**ONBOARD SYSTEMS  
INTERNATIONAL**

## Alert Service Letter

Document No. 159-029-00 Rev. 0

**Subject:** Revised load ring sizes limitations for the TALON 3K Remote Cargo Hook P/N 528-018-01 and -02.

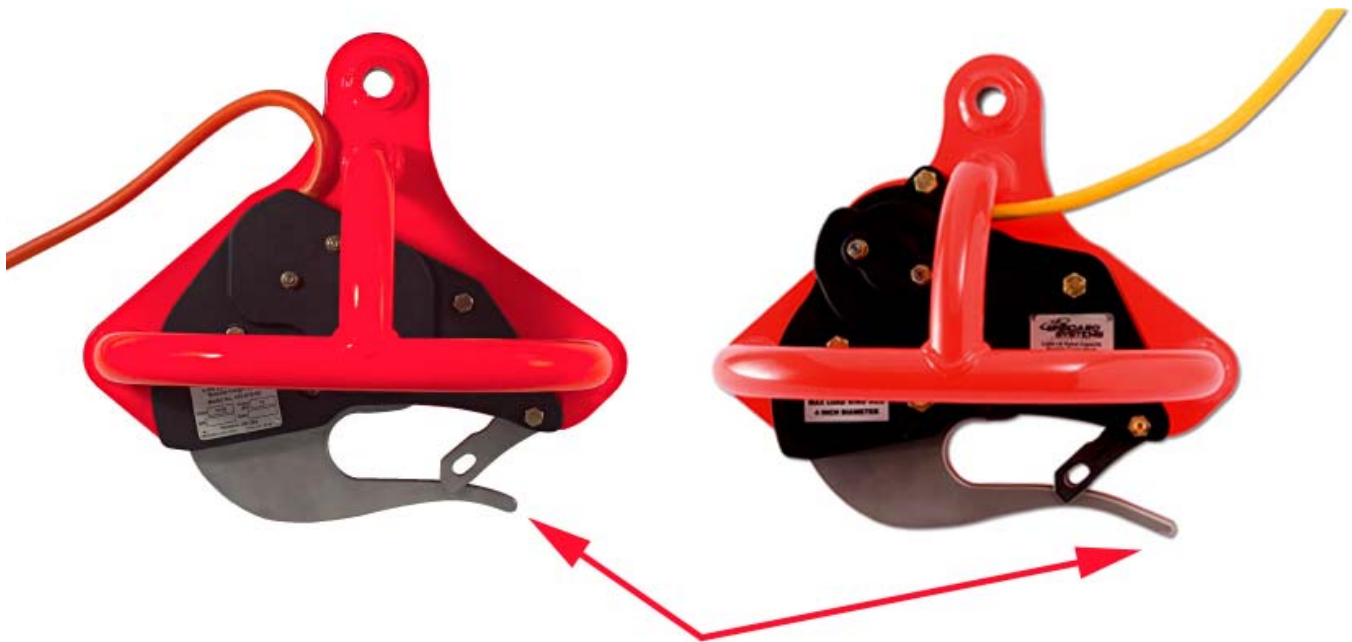
*This Alert Service Letter is only applicable to TALON 3K Remote Hooks that are equipped with the longer load beam, P/N 290-683-01, and that include a "Warning Decal for 4-inch Rigging" applied to the side plate (please refer to Figure 1).*

It has been determined that the load ring sizes originally recommended for this hook are inadequate to prevent the load ring from rolling out past the keeper under all operating conditions. These size restrictions have been modified to correct this issue.

This Alert Service Letter requires the replacement of the existing warning decal with a revised decal and downloading the revised owner's manual.

2. Remove the old warning decal (please refer to Figure 2) from the hook side plate and replace with the new warning decal P/N 215-203-00 (please refer to Figure 3).
